Access Compliance Report

Public Rights-of-Way

Intersection ID: 47920	Main Street: RINGNECK_RD	Cross Street: ROOK_RD	Location:	N
ADA ID: DFA51135AD5C	Ramp Type: PerpDiag	Initial Pass/Fail: Fail	Overall Compliance: No	Severity Score: 10

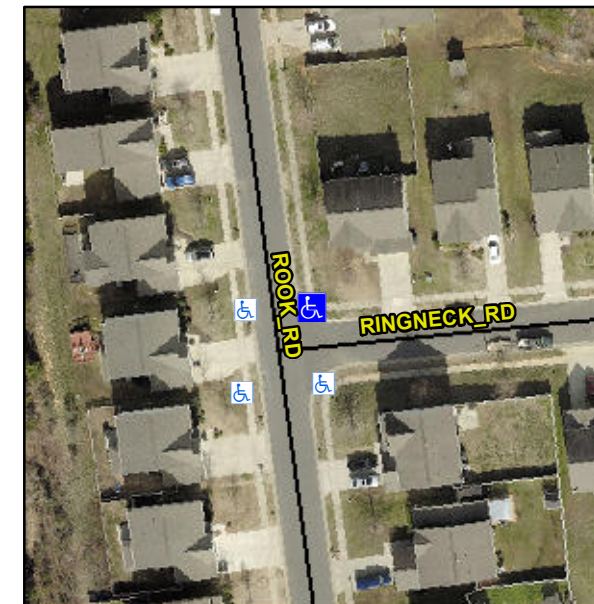
Not Found, R304.5.1, R304.5.3

Compliance	Description	Data	Compliance	Description	Data
N/A	Ramp Length (in)	47.5	Yes	Ramp Slope (%)	7.9
No	Ramp Width (in)	47.0	No	Ramp XSlope (%)	4.5
N/A	Flare Type LT	N/A	N/A	Flare Type RT	N/A
N/A	Flare Slope LT (%)	N/A	N/A	Flare Slope RT (%)	N/A
N/A	Flare Traversable LT?	N/A	N/A	Flare Traversable RT?	N/A
N/A	Landing Length (in)	N/A	N/A	DWS Provided?	N/A
N/A	Landing Width (in)	N/A	N/A	DWS Contrast?	N/A
N/A	Landing Slope (%)	N/A	N/A	DWS Length (in)	N/A
N/A	Landing X Slope (%)	N/A	N/A	DWS Full Width?	N/A
N/A	Landing Curb? (Y/N)	N/A	N/A	DWS Offset (in)	N/A
N/A	Shared Landing?	N/A			
N/A	Gutter Ponding?	N/A	N/A	Gutter Slope (%)	N/A
N/A	Gutter Lip Ht (in)	N/A	N/A	Gutter X Slope (%)	N/A
N/A	Painted X Walk1?	No	N/A	Painted X Walk2?	No
	X Walk 1 Direction	To W		X Walk 2 Direction	To S
N/A	X Walk 1 Width (in)	N/A	N/A	X Walk 2 Width (in)	N/A
	X Walk 1 Slope (%)	1.1		X Walk 2 Slope (%)	4.0
	X Walk 1 X Slope (%)	3.0		X Walk 2 X Slope (%)	0.2

Remove & Replace Curb Ramp With Two New Directional Ramps or Equivalent.
